SERVICE BULLETIN

APPLICABILITY: 2013-2017MY Impreza
 2013-2017MY Crosstrek
 2012-2017MY Forester, NA and Turbo
 2015-2017MY WRX
 2013-2017MY BRZ

NUMBER: 02-166-17R

SUBJECT: Upper Oil Pan Assembly- Design Changes

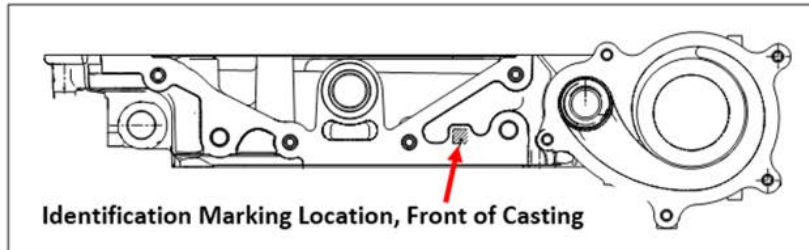
This bulletin outlines design changes made to the upper oil pan assembly on FA and FB engines used on the models listed above. There have been isolated cases where the sealer used between the upper oil pan and the crankcase has become displaced resulting in engine oil seepage.

- The mating flange thickness of the casting in the area identified as the cause for the seepage has been increased by 5.5mm. (See images provided in the Parts Information section below.) This thickness increase creates the need for a longer bolt to provide proper tightening and retention.
- An additional mounting point has been added to the ribbing inside the casting to increase retention of the steel baffle plate and eliminate vibration.

NOTE: Always confirm the most recent part number upper oil pan is ordered whenever replacement is necessary along with the required additional bolts and one-time use sealing parts.

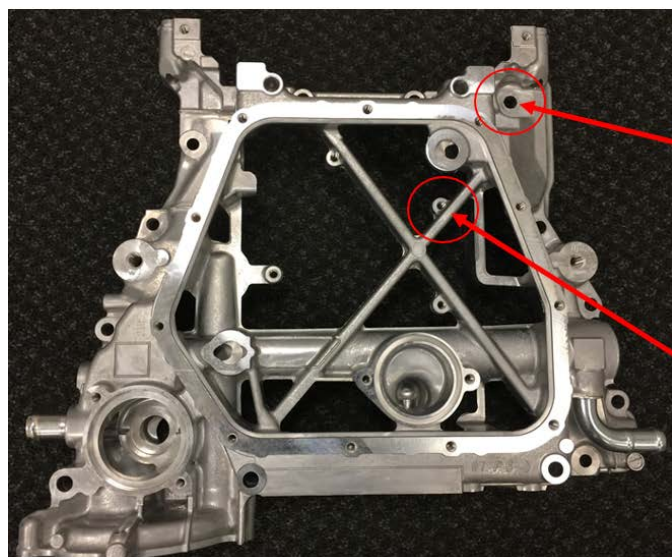
- An underscore has been added to the identification letter found on the front face next to the water pump cavity and QR code box.

- Thicker casting and an additional mounting point for the baffle plate added to the internal ribbing.

Because the thickness of the casting has been increased by 5.5mm in this area, a new, longer socket-head cap screw, p.n. 800408250 is required replacing the original hex head bolt.

An additional mounting point / bolt hole has been incorporated here to improve retention of the baffle plate. Use hex bolt p.n. 808206010.
